# Mixed hotel, residential and retail development 33 Cross Street, Double Bay

August 2009

Prepared for Ashington

Major Project Application 08\_0100  
Preferred Project Report

**Figure 10: Cross Street elevation showing the reduced height and the four storey podium to Cross Street**

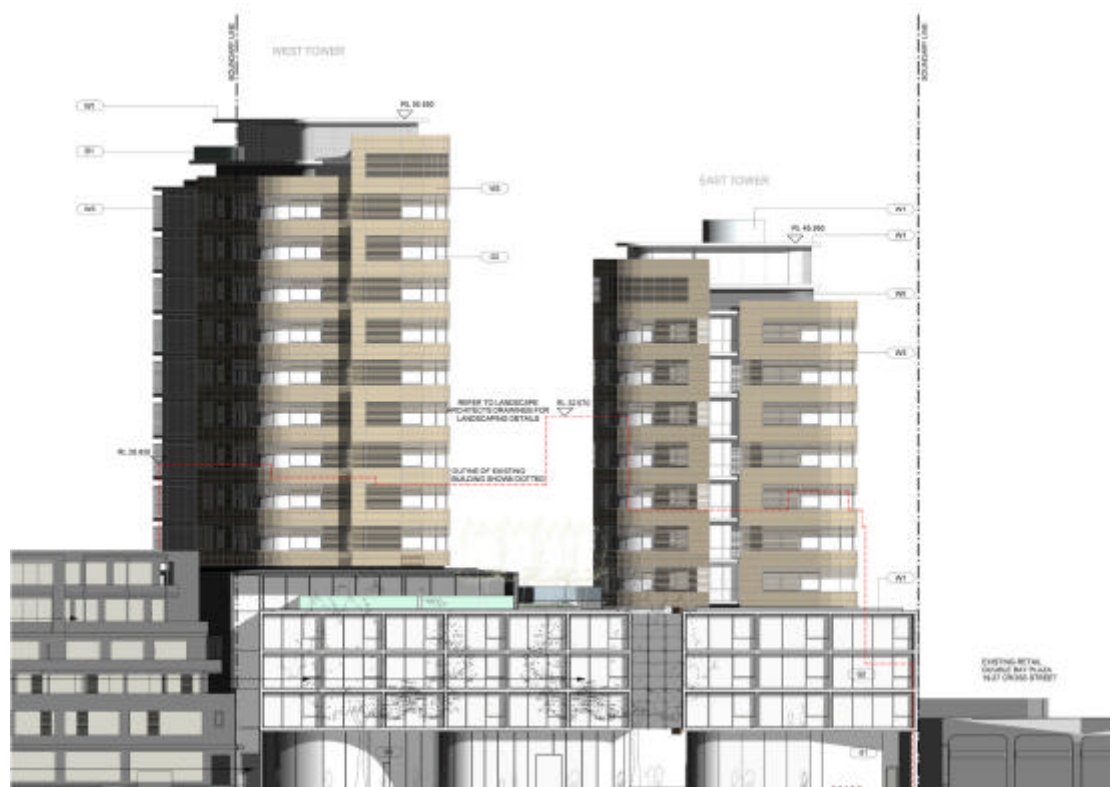
It is important to consider the proposed reduction in height with the overall bulk and scale of the development. It is desirable to minimise the size of the tower floor plates. The larger the floor plates the more bulky they would appear. The overall objective is to minimise the bulk of the development, to maintain separation between the towers and to sit the taller elements appropriately to maintain a 4 storey street wall height to Cross Street.

Figure 12. Preferred Project shadow diagram June 21 9.00am

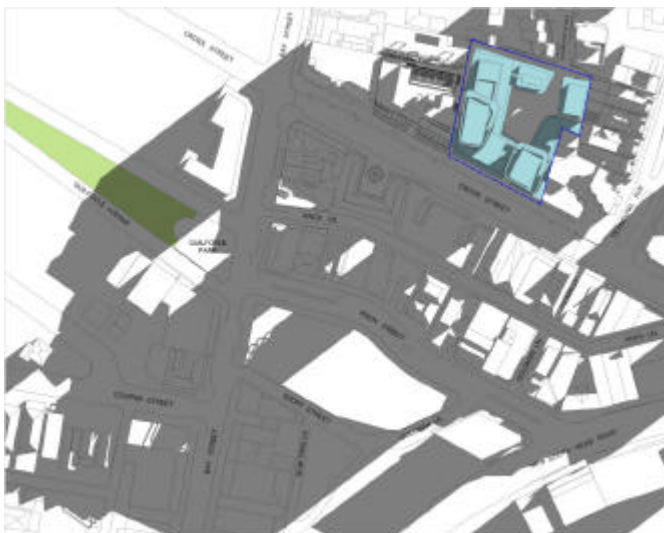
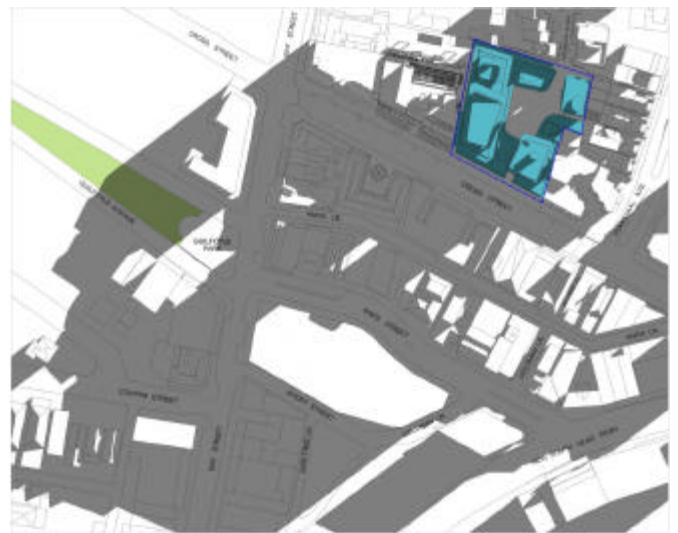
In comparison with the EA scheme, the Preferred Project shows a improvement in the level of shadowing, particularly to the southern side of Cross Street, which will now achieve at least 3 hours solar access to these properties and to the corner of Transvaal Avenue and Cross Street in the afternoon.

Figure 29. Section through Northern podium

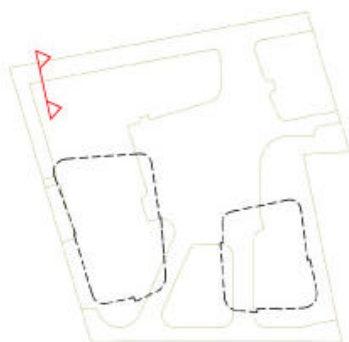
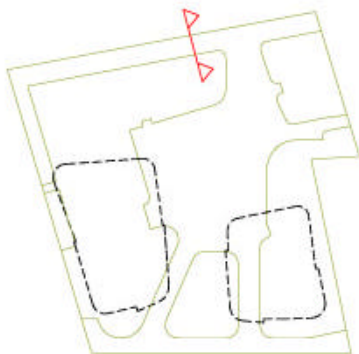
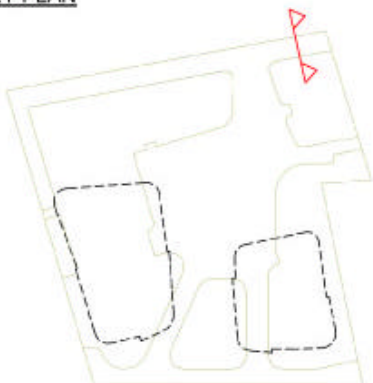
Figure 29, Figure 30, Figure 30, Figure 31 show sections through the development and its relationship to the adjoining residential properties to the north. In comparison to the Environmental Assessment scheme.

The additional screening on the northern elevations will assist in mitigating direct overlooking opportunities.

Figure 33. Photo of the model - South Eastern elevation of Option 1

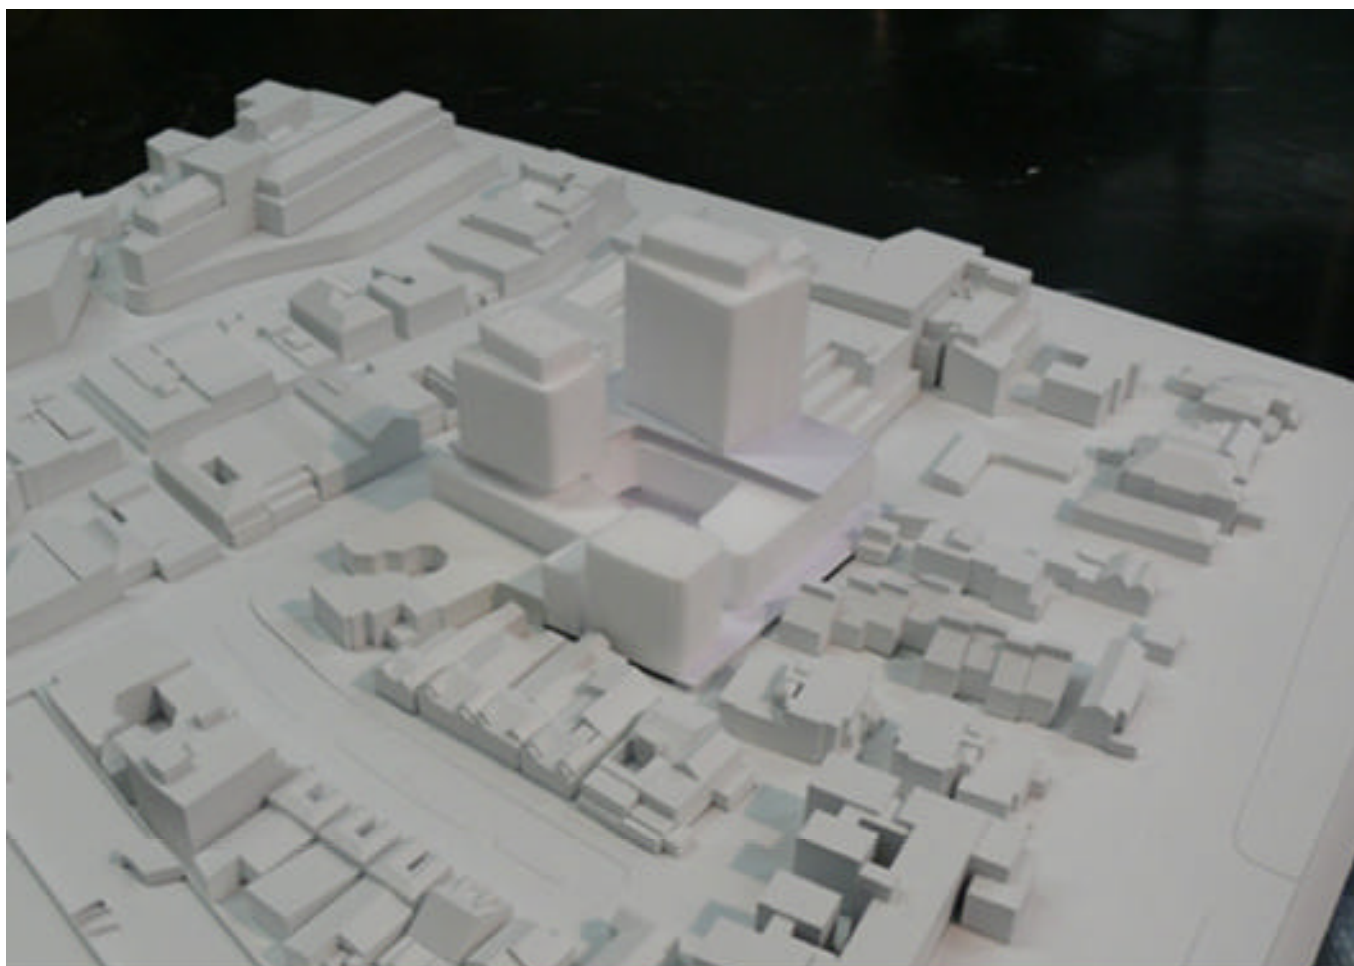
In addition to the common changes introduced for all options described above, option 1 includes the following design amendments when compared with the Environmental Assessment proposal:

- Reduction in the height of the south eastern tower from 15 storeys to 11 storeys plus plant room;
- The south eastern tower will remain the same floor plate size as the Environmental Assessment proposal.
- No change is proposed to the height or bulk of the north eastern tower.
- No change is proposed to the height or bulk of the south western tower.

Figure 35. Photo of the model - South Eastern elevation of Option 3

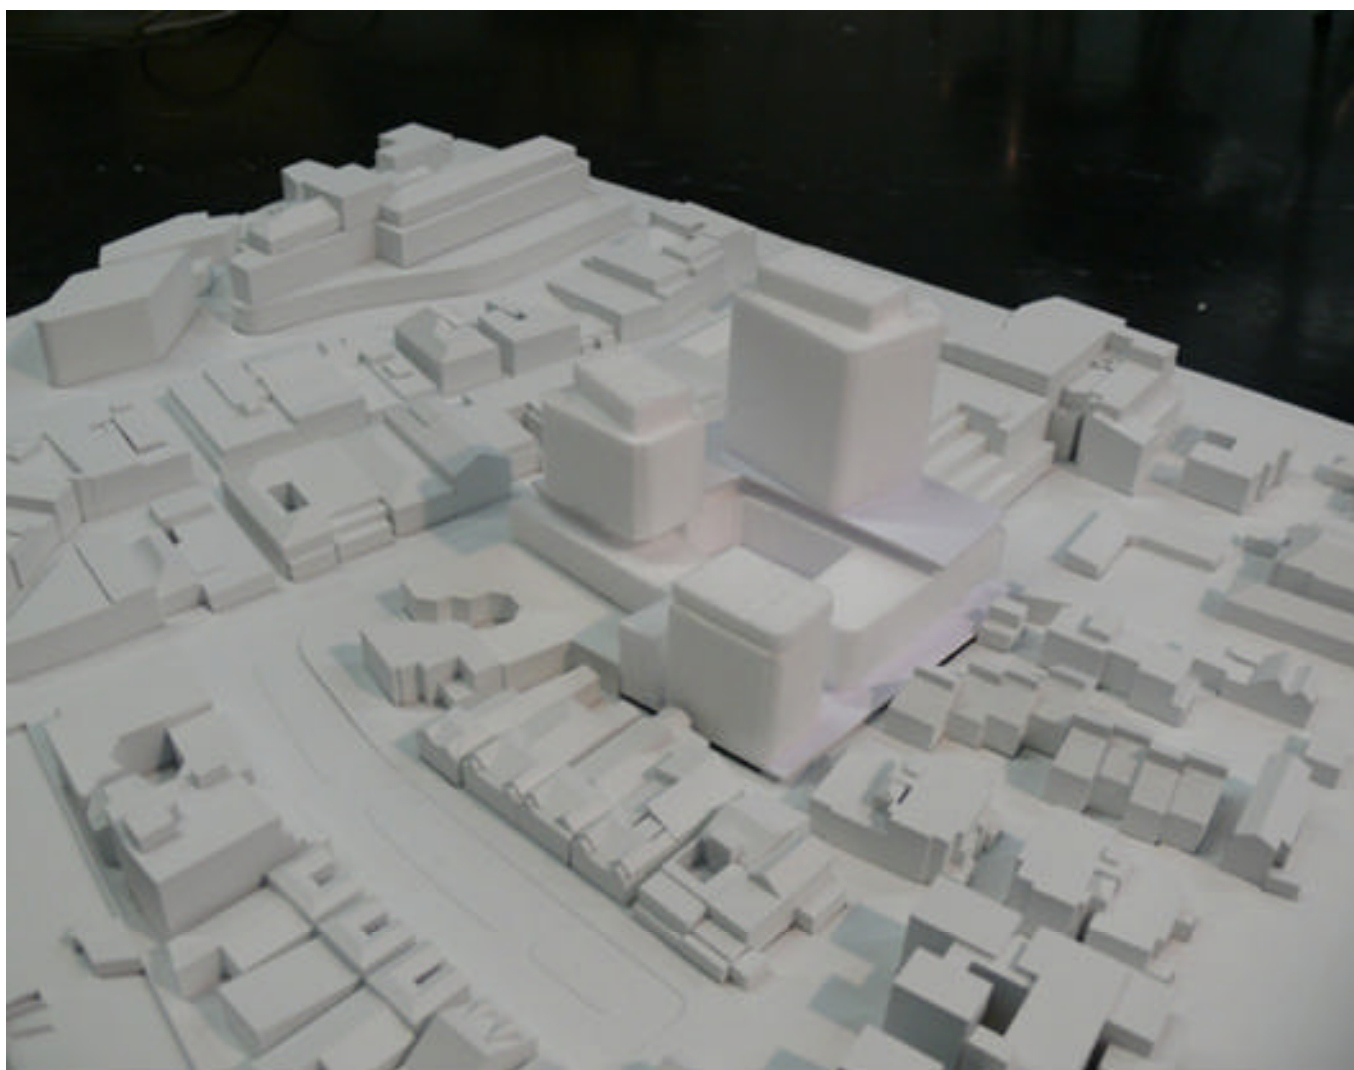
Option 3 includes the following design amendments in addition to the common design amendments when compared with the Environmental Assessment proposal:

- No change to the height of south western tower at 15 storeys with an increase to the floor plate size;
- A reduction in the height of the south eastern tower from 15 storeys to 10 storeys plus plant and no increase in the floor plate size;
- An increase in the height of the north eastern tower from 6 to 7 storeys.

Figure 37 Preferred Project Section illustrating the varying height

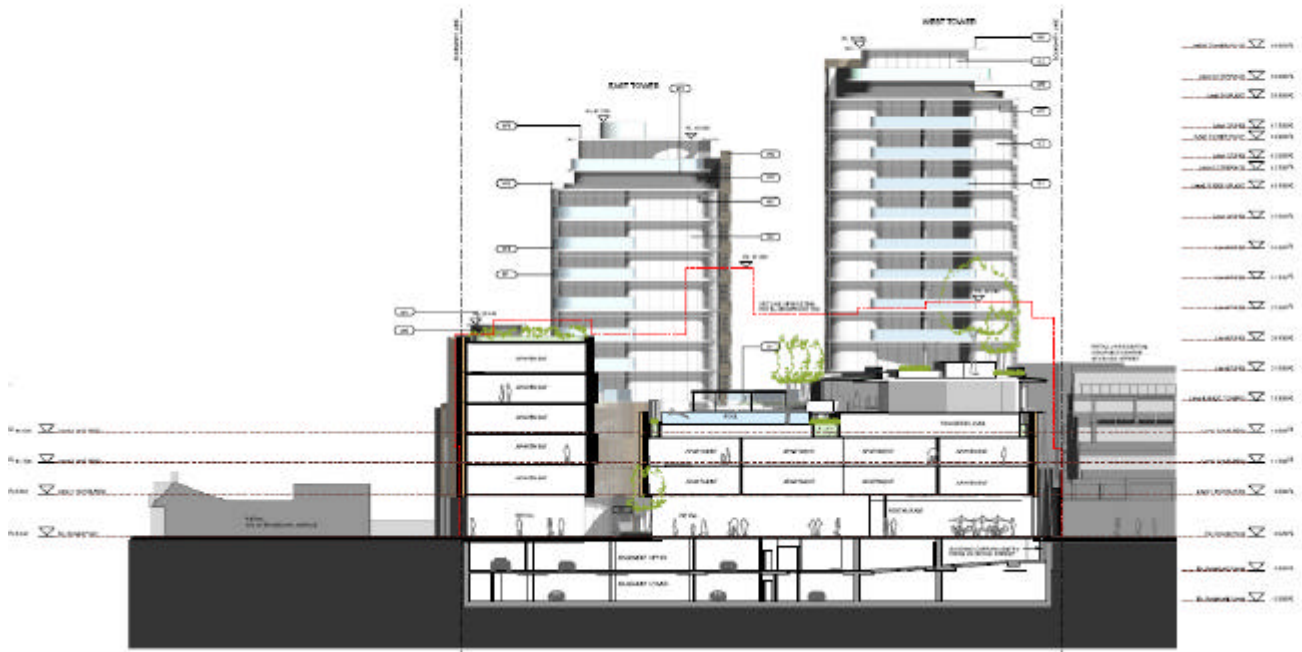
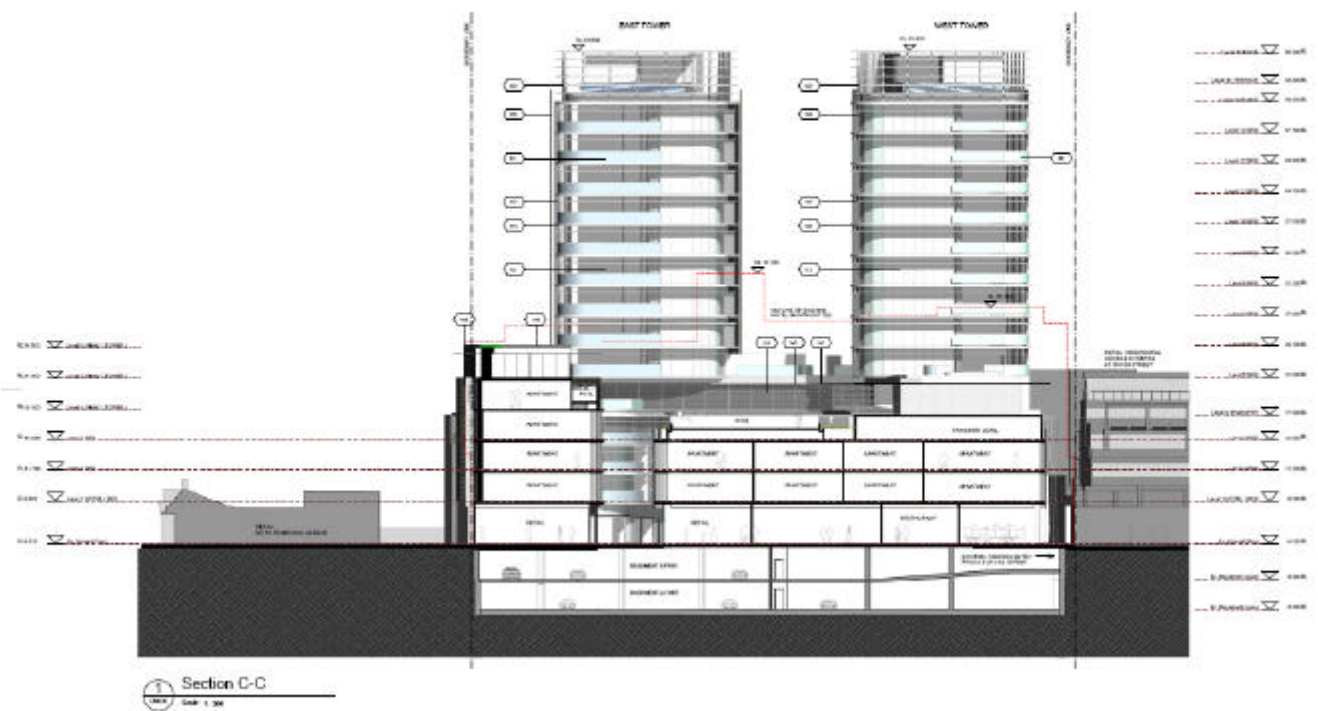
The preferred project has reduced the overall height of the eastern tower by 7.8 metres (RL 47.750, 43.73 metres to the top of the plant roof). The previous height of the eastern tower was RL 55.650, 52.63 metres.

In Figure 11 and Figure 12 detail a comparison in terms of height of the development from the EA scheme to the PPR scheme. It is clear that the height of the eastern tower has been significantly reduced, whilst the height of the western and northern towers have been retained.
